January 23, 2023

RE: Definitive Subdivision Plan-Peer Review
#1355 Main Street
ZP Battery Devco, LLC
Map 26/Parcel A1

EMERGENCY VEHICLE TURNING MANEUVER

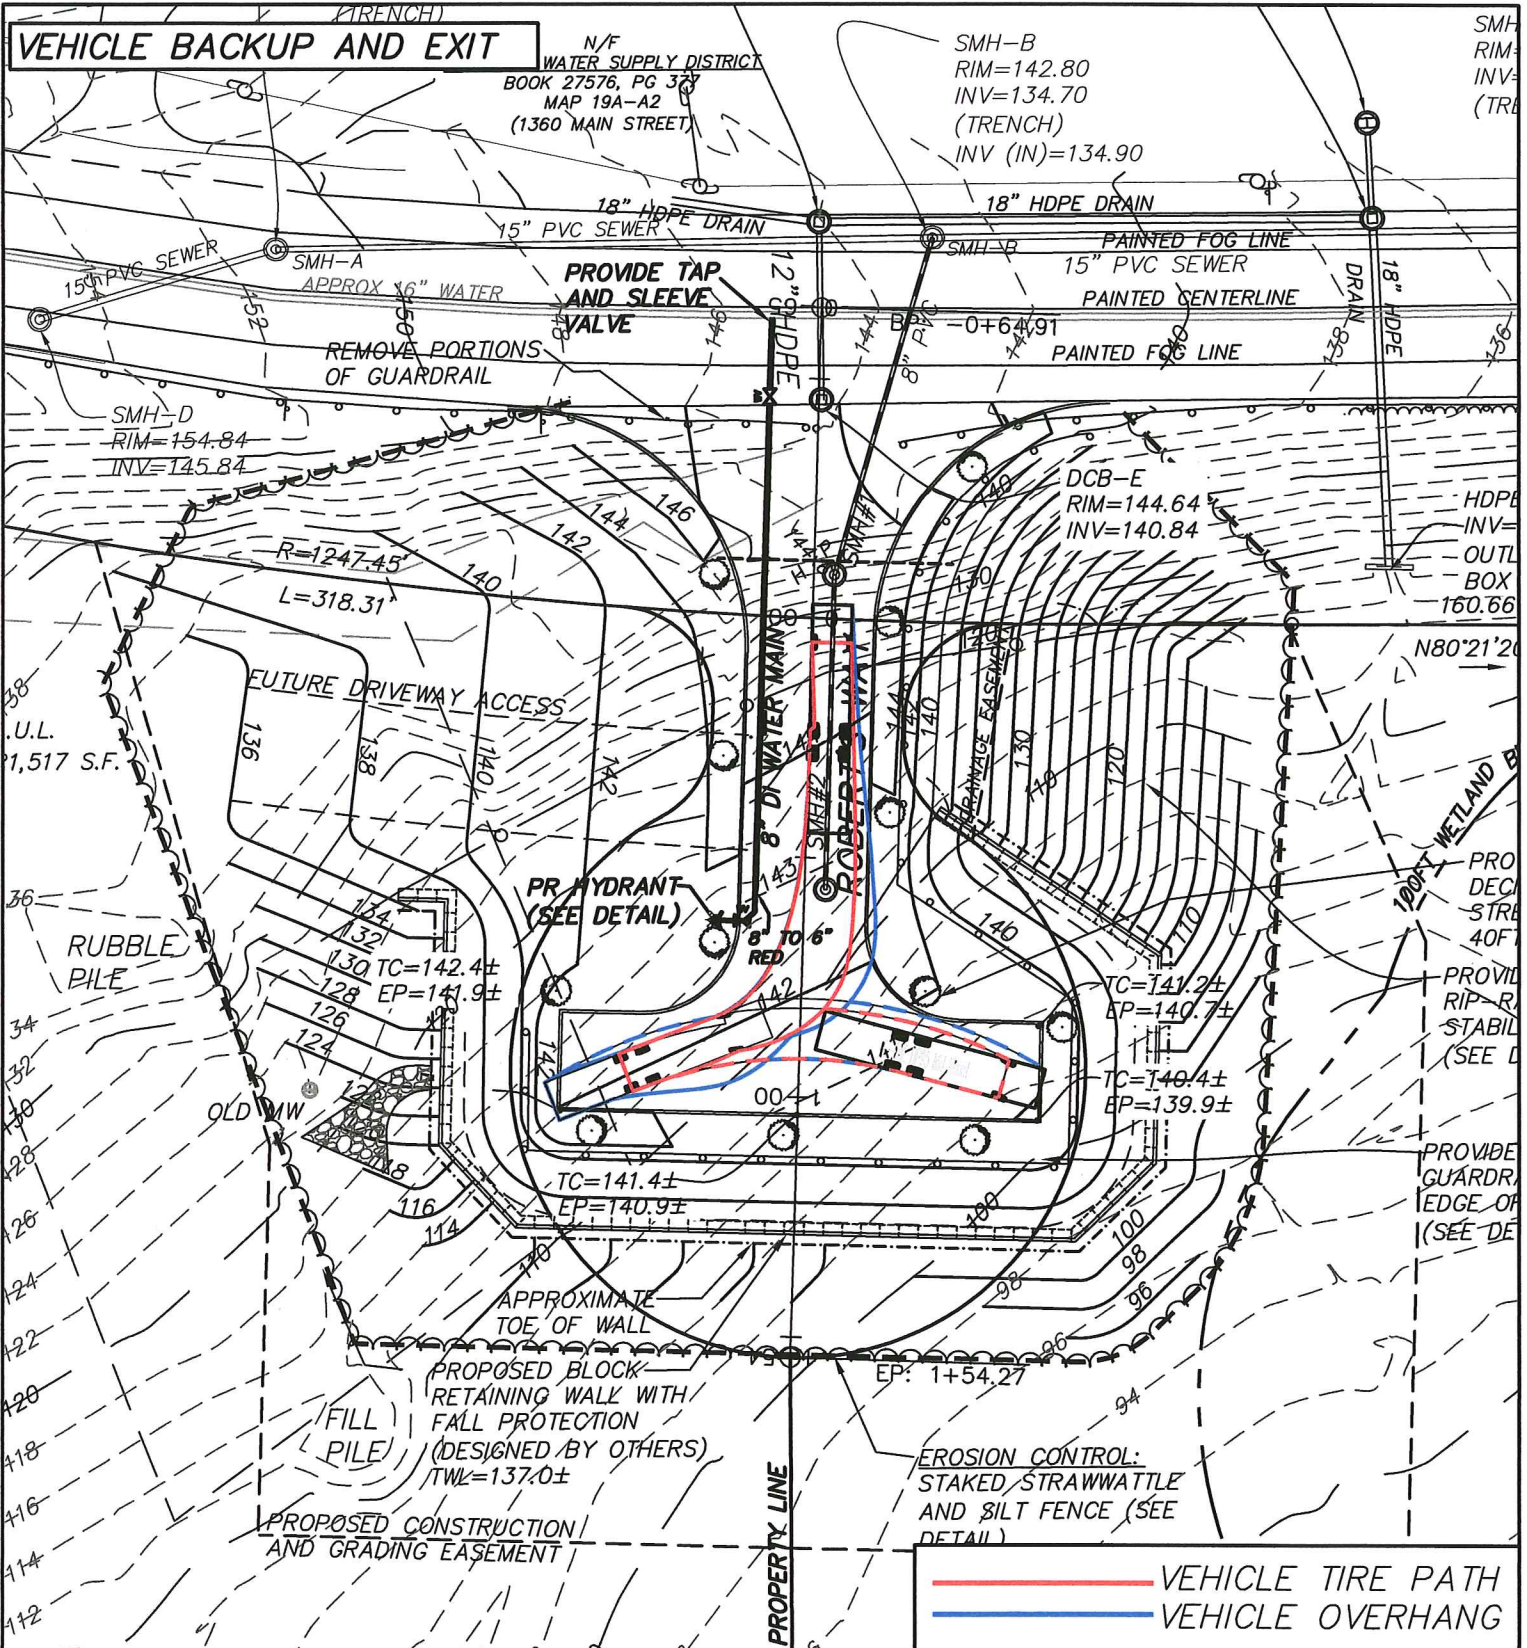
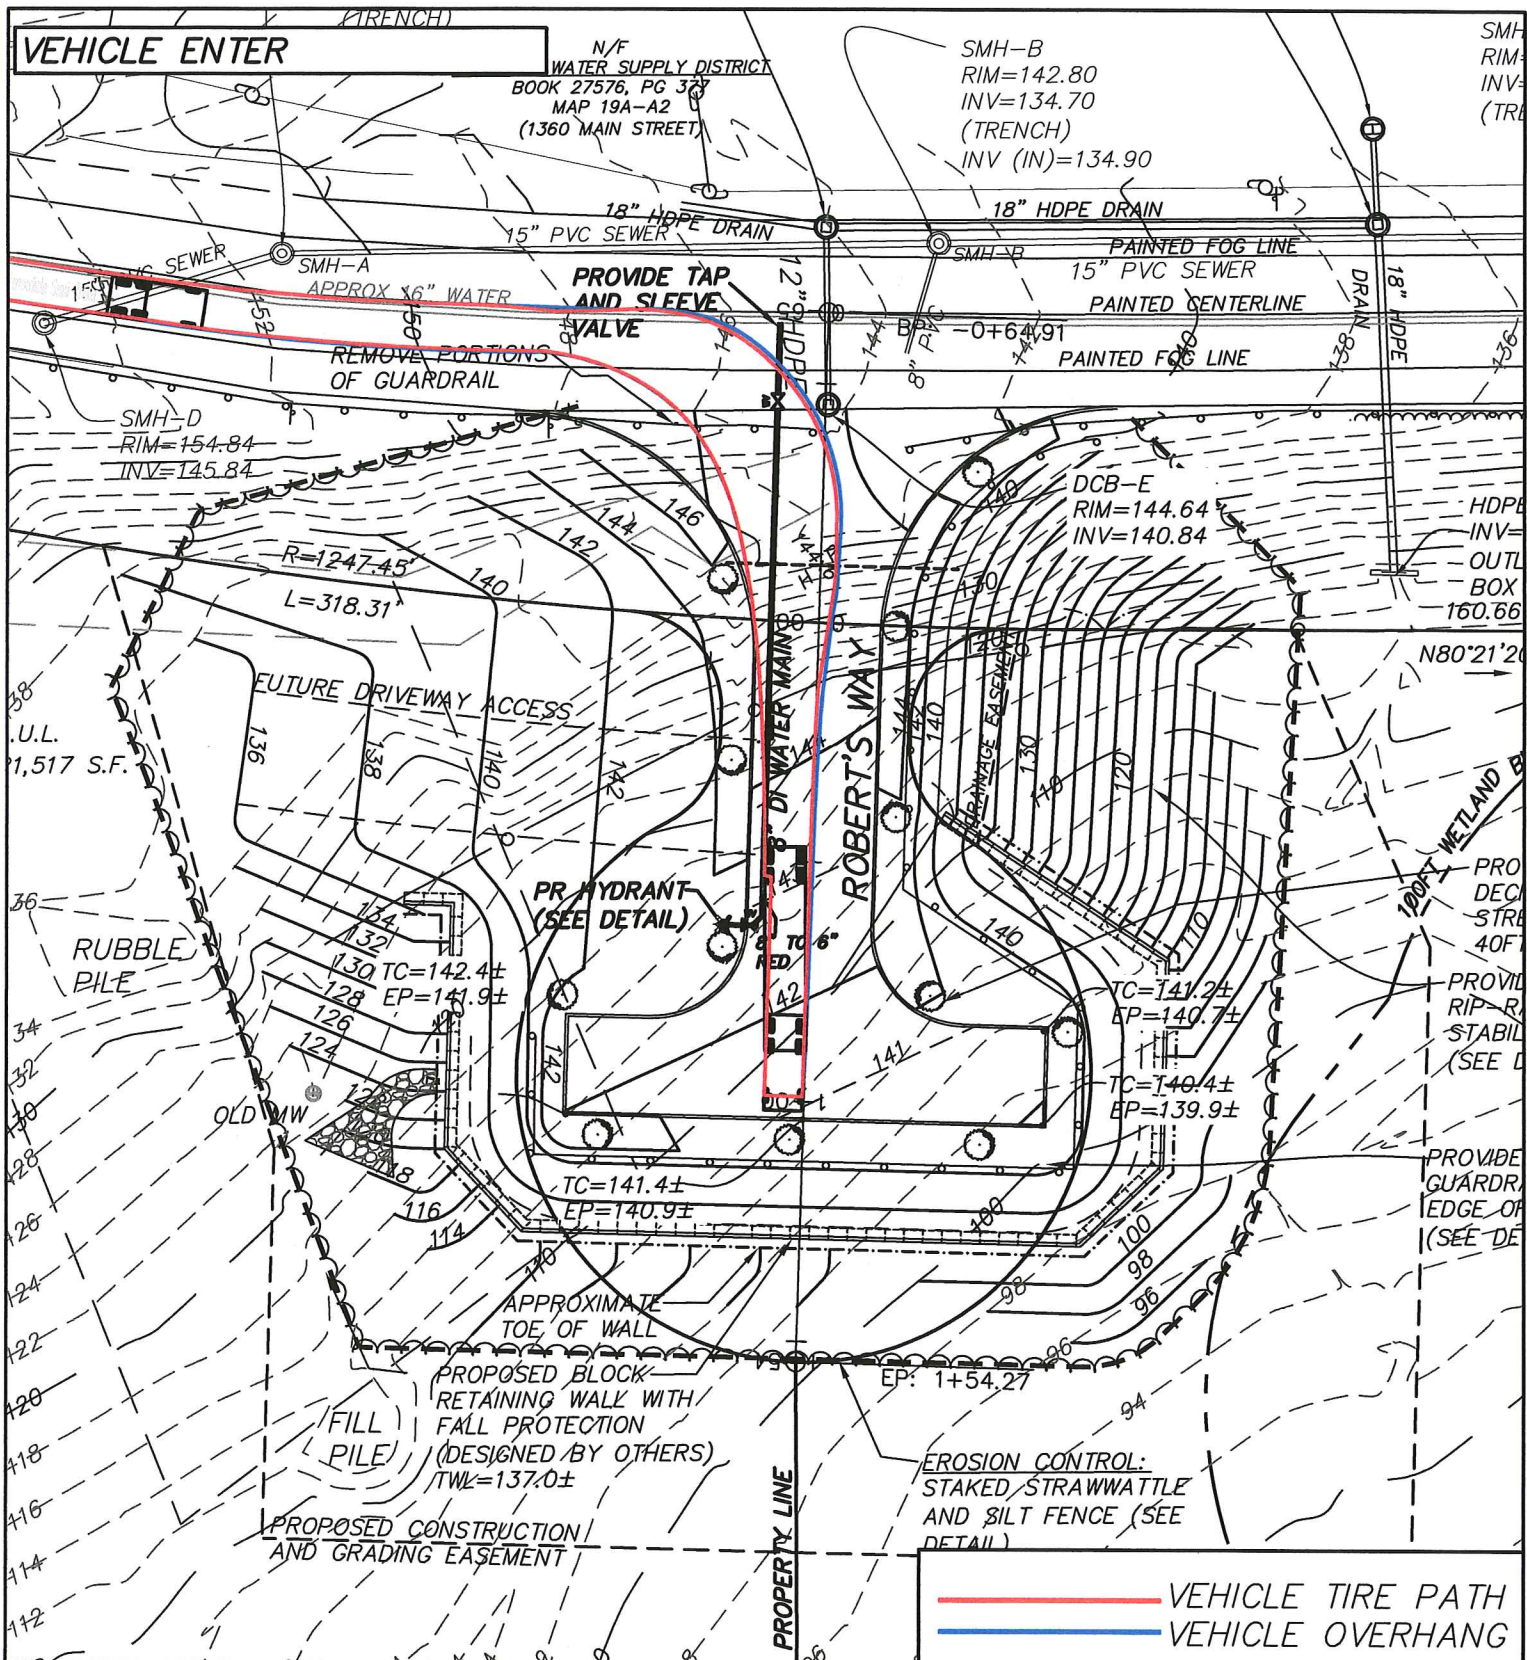
Comment #4: On the Emergency Vehicle Turning Maneuver diagrams provided, the blue lines overlap berm in several locations. The blue lines are not defined, but may depict vehicle "overhang" and not actual tire paths. Engineer should clarify.

Response: The provided Emergency Vehicle Turning Maneuver diagrams depict both the path of the outer edge of the vehicle tire, as shown in red, and the overhang of the vehicle depicted as blue. These diagrams have been revised to depict this color scheme

WB-50 VEHICLE TURNING MANEUVER

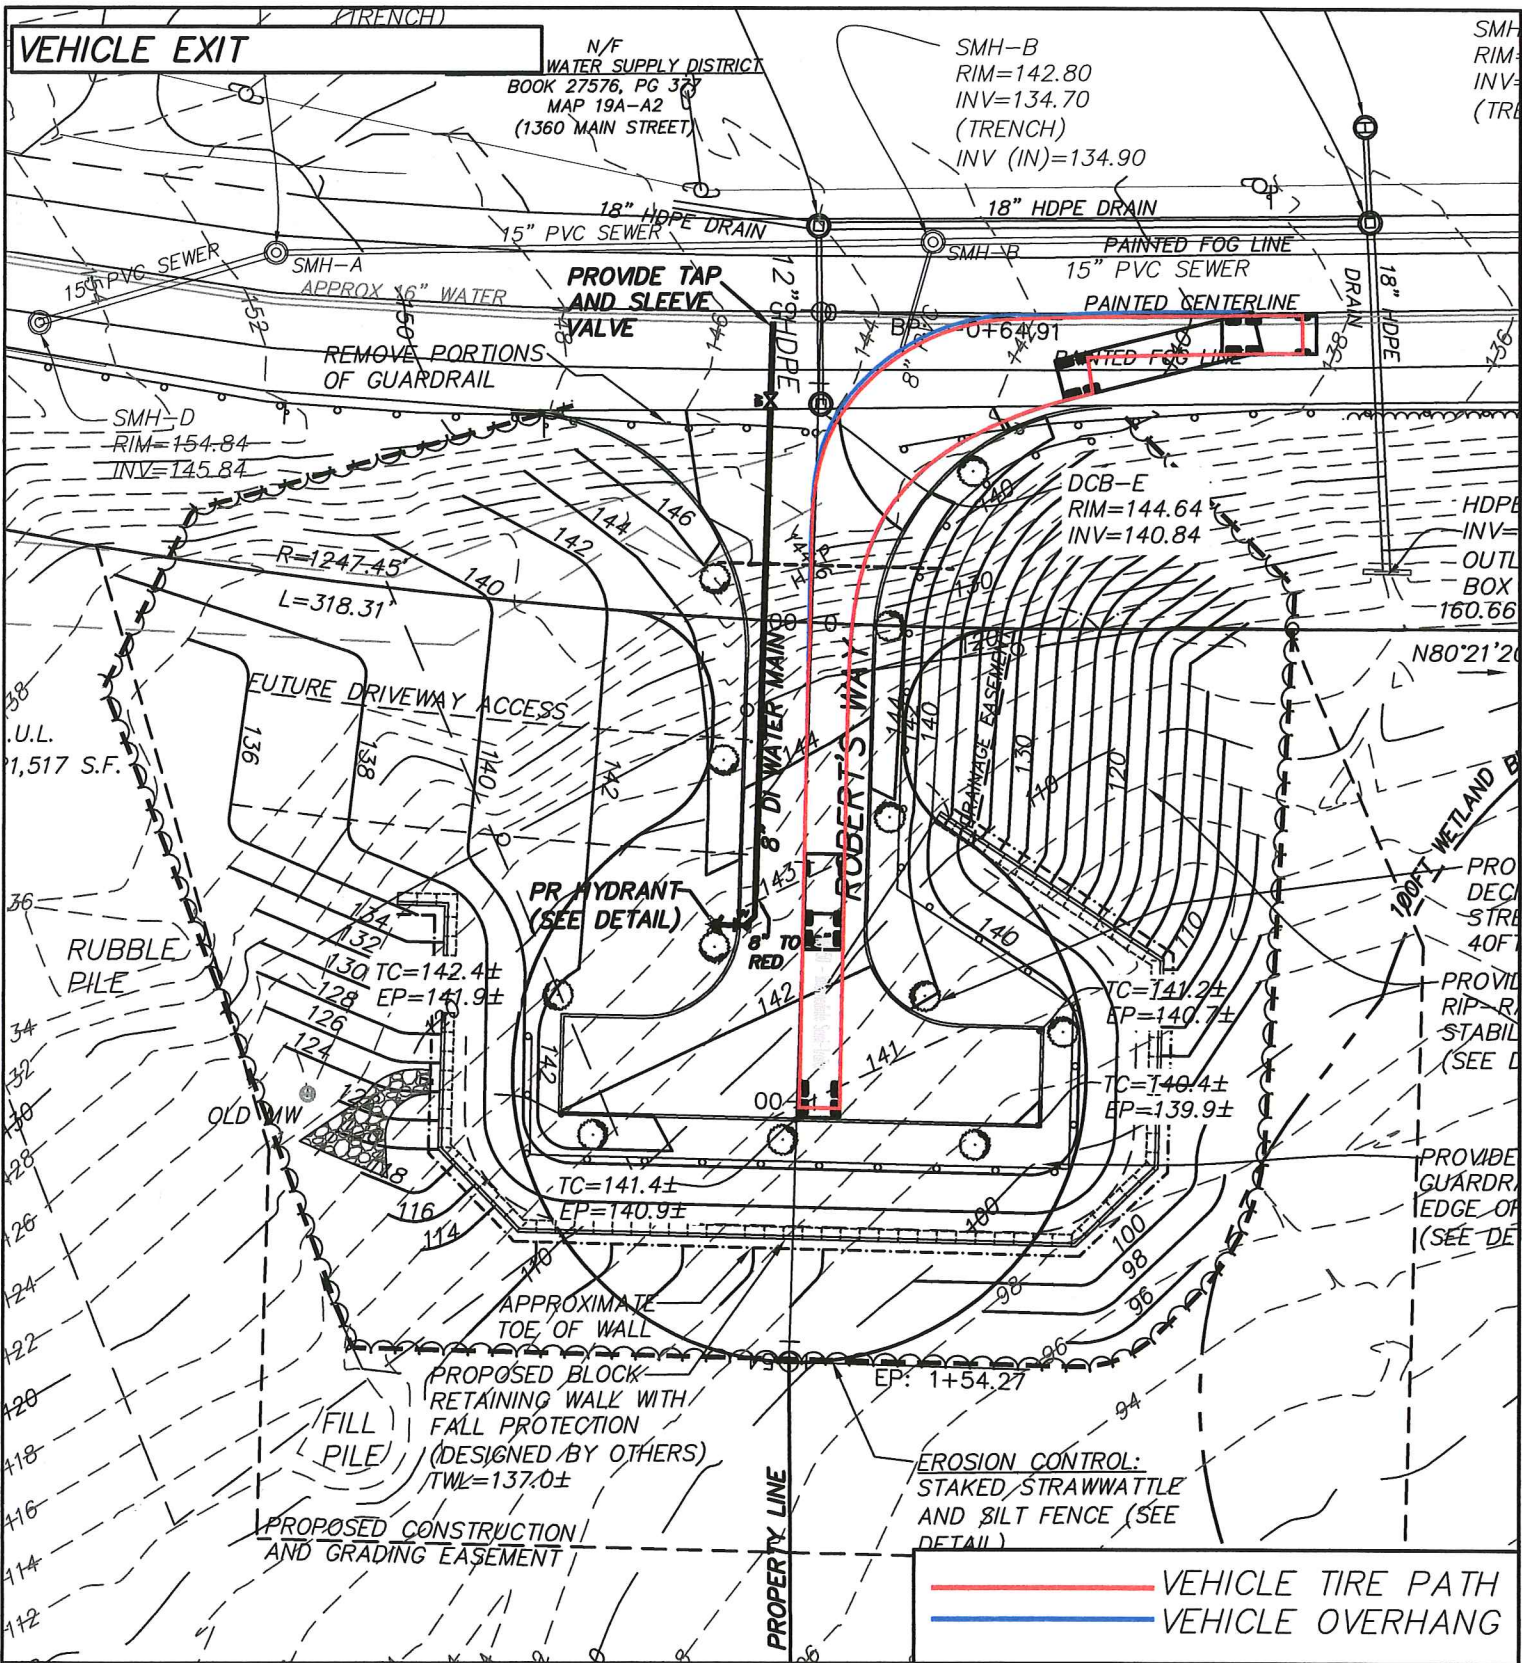
Comment #6: §VI.R.4, Berm Radii, Industrial Subdivisions. Waiver requested to permit reduction of the radius of curvature of berm at the entrance to Main Street of 20 feet in lieu of required 50 feet.

§VI.R.3 and §VI.R.4 pertain to road geometry required to accommodate vehicles using the roadway, and entering and departing the subdivision. As a public road which services an industrial subdivision, the road should be capable of accommodating tractor-trailers or other large vehicles.

There is a safety concern for larger vehicles departing the project and entering Main Street, particularly in the southbound direction. Vehicles must be able to make the swing onto Main Street without crossing the centerline. If the width of the proposed road and/or the rounding of the curb are so narrow that trucks are unable to make the turn onto Main Street without crossing into the opposite travel lane, a serious safety hazard will exist. The Engineer must submit diagrams documenting the turning maneuvers for large vehicles, including tractor-trailers. It is the opinion of this office that a municipal road should safely accommodate large vehicles, irrespective of what type of vehicle might be expected to use the subdivision.

Nonetheless, for the purposes of this review a WB-50 vehicle, was modeled turning into and out of this site ascertain the ability to accommodate larger vehicles entering the site. To accommodate these larger vehicles the proposed roadway has been increased to 26-feet and the entrance radii increased to 50-feet to account for the swing of the trailer entering and exiting the site. It is anticipated that when the lots get developed these larger trucks would enter into their respective properties, perform their function and then exit the site. As such actual reverse direction turning maneuvers would not occur within the T-Turnaround of the subdivision.
